Widening of SR 107 From I-75 To SR 11/US129

Value Engineering Study Report

August 2009

Re: Widening of SR 107 from I-75 to SR 11/US 129
Project No. STP-0000-00(311), P.I. No. 0000311
Project No. STP-0000-00(314), P.I. No. 0000314
Project No. STP-0000-00(313), P.I. No. 0000313
Value Engineering Study Report

2/4
Alt. G-1

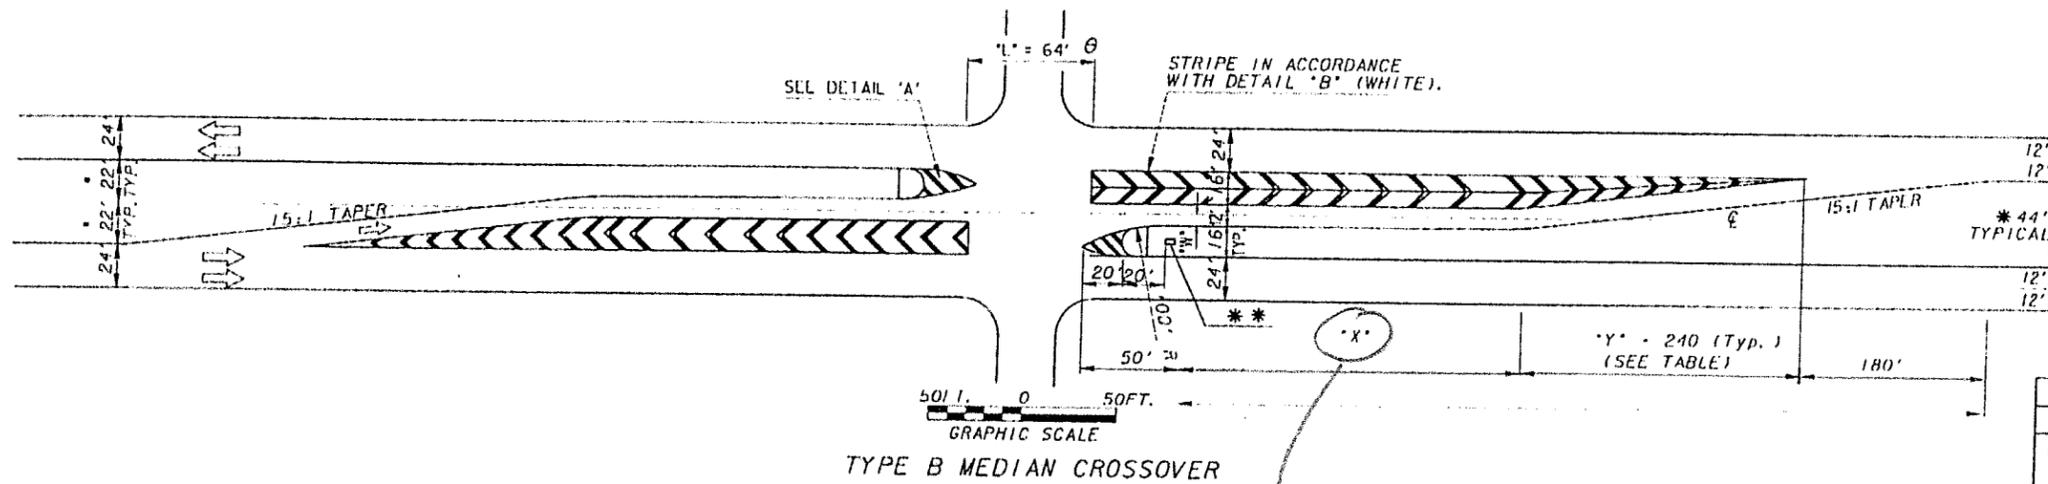
The original design uses the maximum “x” length of 450 ft for storage and deceleration for left-turn lanes per GA. Construction Detail M-3.

Use the minimum “x” length of 300 ft for storage and deceleration for left-turn lanes per GA. Construction Detail M-3.

ALTERNATIVE NO.: G-11

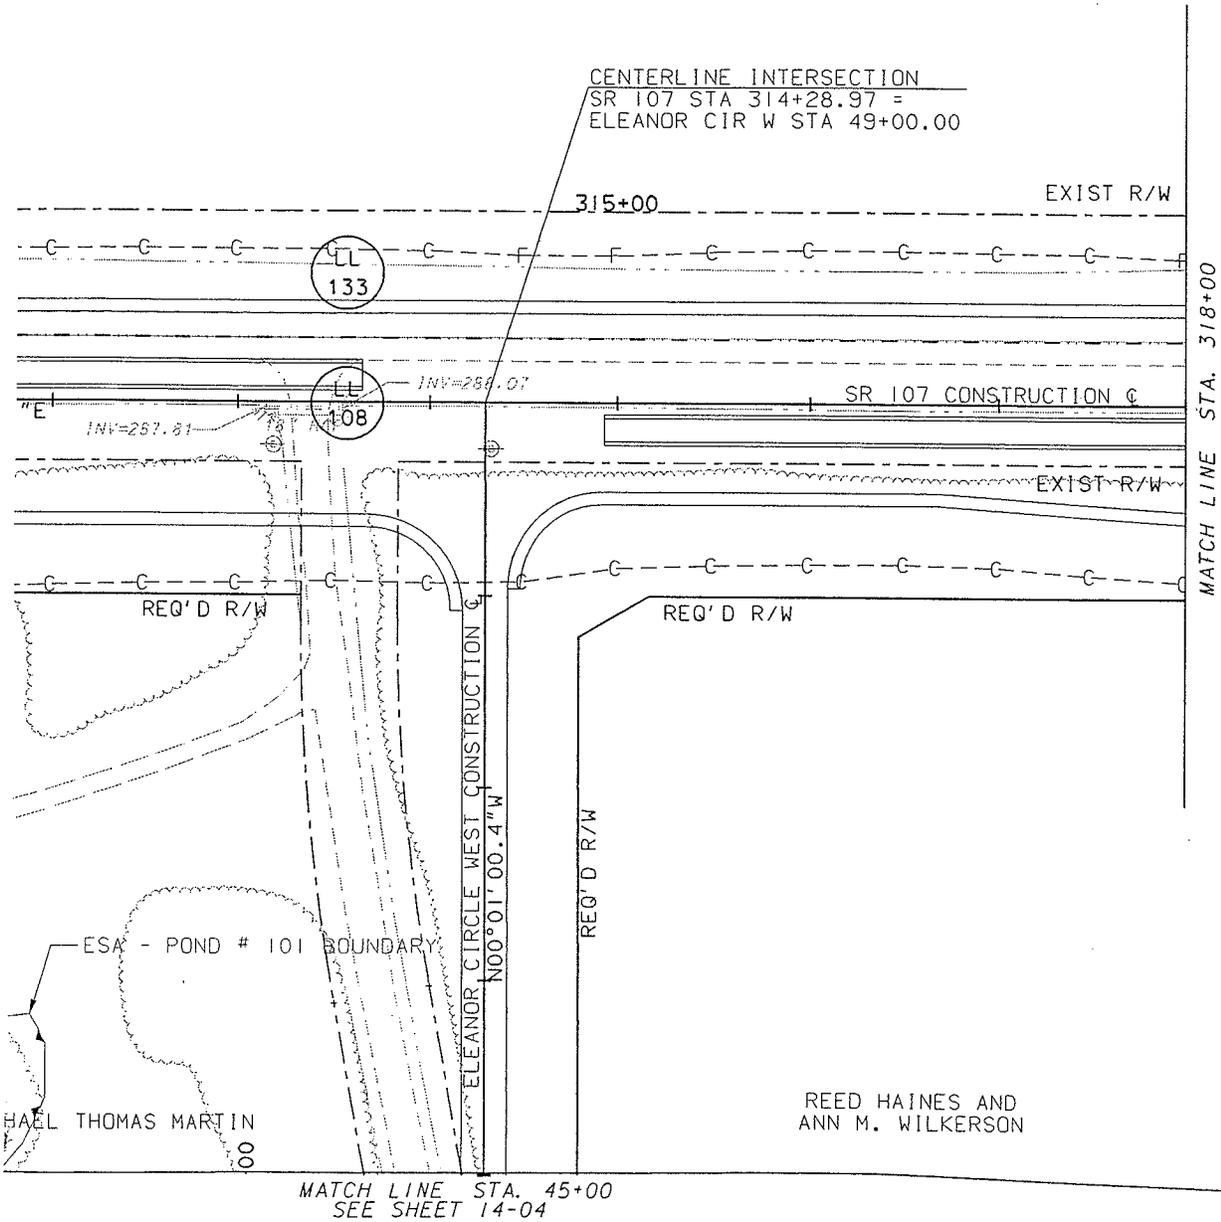
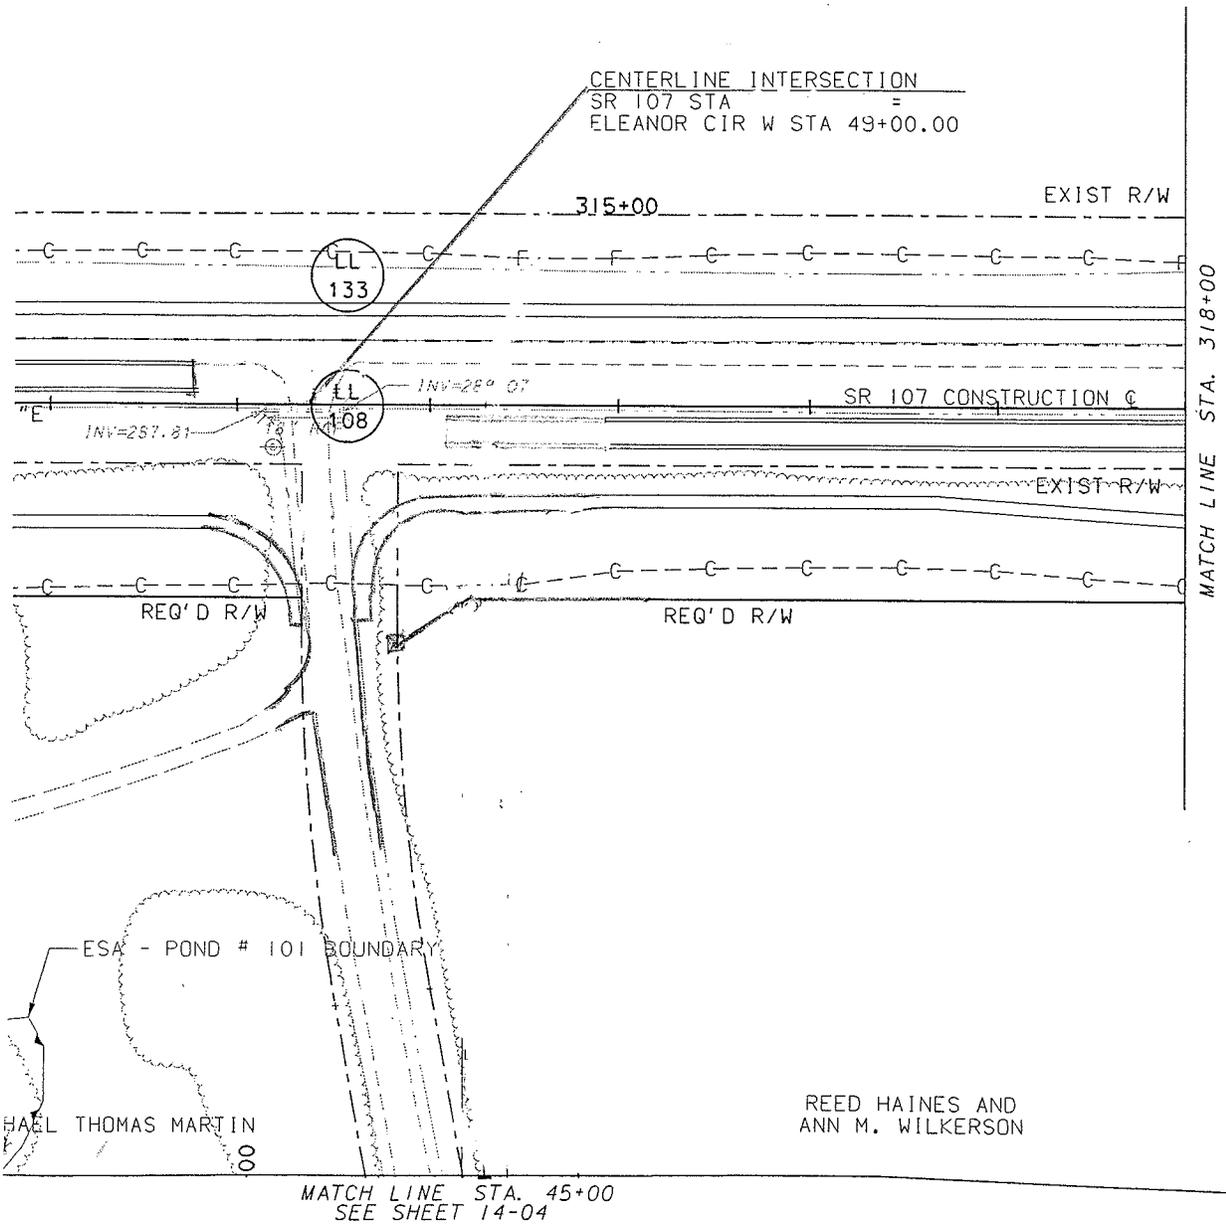
COST SUMMARY	INITIAL COST	PRESENT WORTH RECURRING COSTS	PRESENT WORTH LIFE-CYCLE COST
ORIGINAL DESIGN	\$ 94,347	—	\$ 94,347
ALTERNATIVE	\$ 31,173	—	\$ 31,173
SAVINGS	\$ 63,174	—	\$ 63,174
